## NORFOLK BOREAS OFFSHORE WIND FARM – EVIDENCE FROM SUBMISSIONS TO HORNSEA 3 AND NORFOLK VANGUARD PLANNING ENQUIRIES.

Summary of Cawston Parish Council's submissions of evidence to the National Infrastructure Planning Inquiries for the Hornsea 3 and Norfolk Vanguard Wind Farms.

Extract from *Nfk Vanguard EN010079-001322-2.02 Onshore Land Plans.pdf* showing parts of sheets 19 and 20.

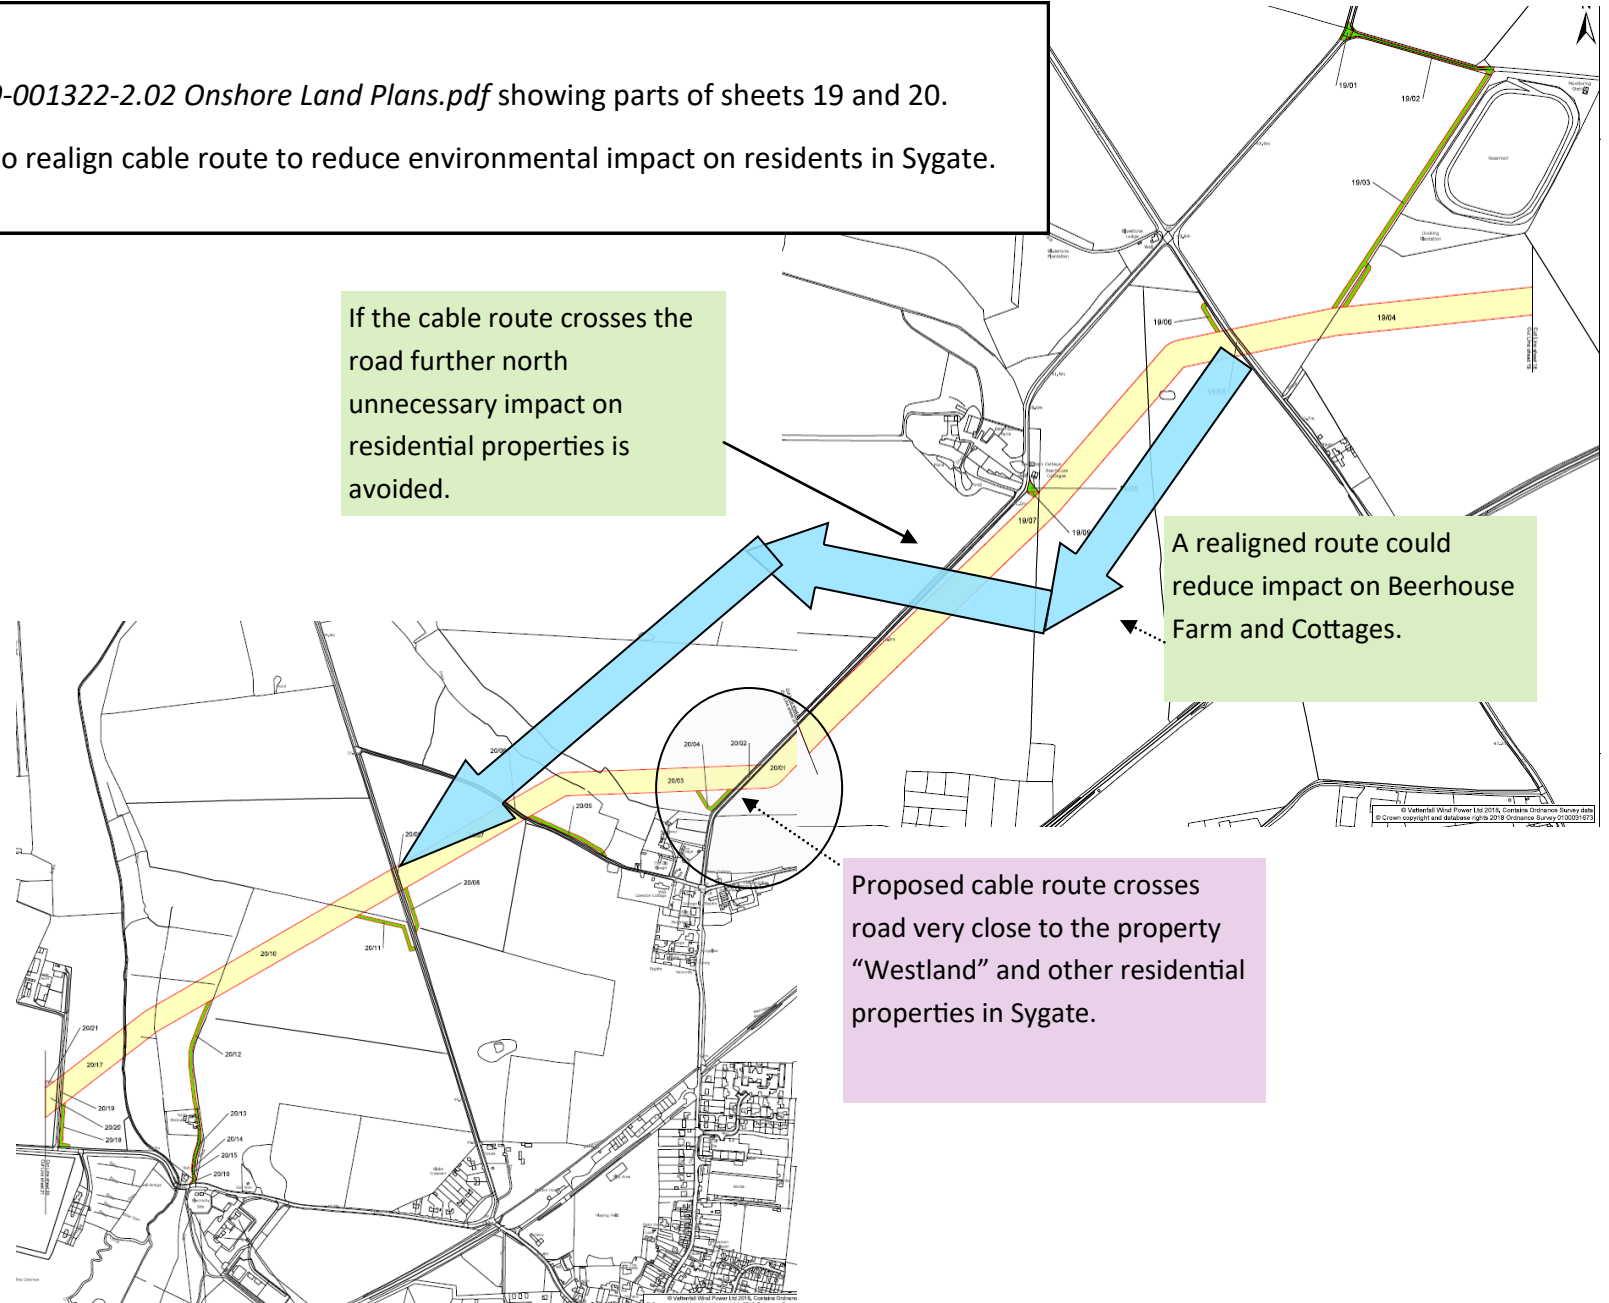
Annotated to show the opportunity to realign cable route to reduce environmental impact on residents in Sygate.

If the cable route crosses the road further north unnecessary impact on residential properties is avoided.
